This TSI Service Bulletin replaces the following TSI Service Manual Supplements: 200–750–01, "Intermediate Gear, Higher Torque" (11.99), publication no. PV776–200–750–01SB; 200–760–01, "Intermediate Gear, Higher Torque" (11.99), publication no. PV776–200–760–01SB; and 200–770–01, "Intermediate Gear, Higher Torque" (11.99), publication no. PV776–200–770–01SB.

Date Group No. Supp. Page 12.2001 **215 008** 1(2)

Intermediate Gear Tightening Torque TD122, TD123

Fig. 1: installing intermediate gear

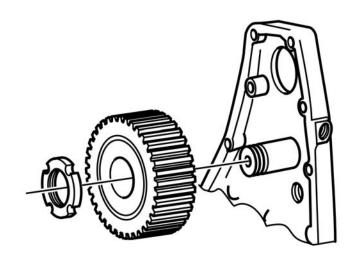
A higher torque is specified for the nut for the intermediate gear on TD122 and TD123 engines.

- A new nut is used to install the intermediate gear. It should be installed with the flat surface against the ball bearing. This nut no longer uses a washer and lock ring. (See Fig. 1: installing intermediate gear, page 2.)
- The new nut should be torque-tightened to 190 ± 10
 Nm (140 ± 8 ft-lb) using pin spanner 9996682. (See Fig. 2: 9996682, pin spanner, page 2.)
